Technical Bulletin

Bulletin Number: UTB-052218

Product: Utica StarFire Steam Boilers - SFE IV to SFE V

Title: Starfire LWCO Probe Location Change

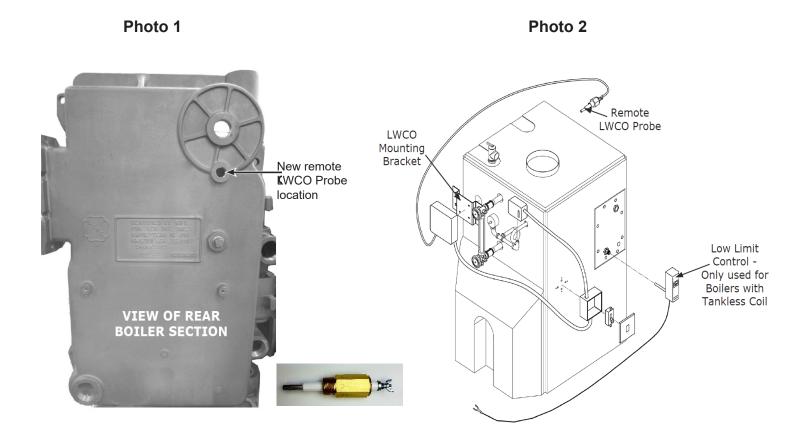
The current SFE IV oil fired steam boilers have the LWCO control and probe installed on the front section of the boiler. During steaming, the front of the boiler generates more steam than the rear of the boiler. This causes a density change. The less dense water in the front of the boiler is pushed higher by the denser water in the back of the boiler, causing a slightly slanted water line. The slanted water line has no effect on the boiler's ability to make dry steam. However, since the water line is slightly lower in the back section, it is logical to have the low water cut off monitor water level in the back section rather than the front section.

Utica Boilers will be implementing a remote style LWCO sensing probe which will be in the back section of the casting. Locating the probe in the back section will provide the most accurate water level sensing.
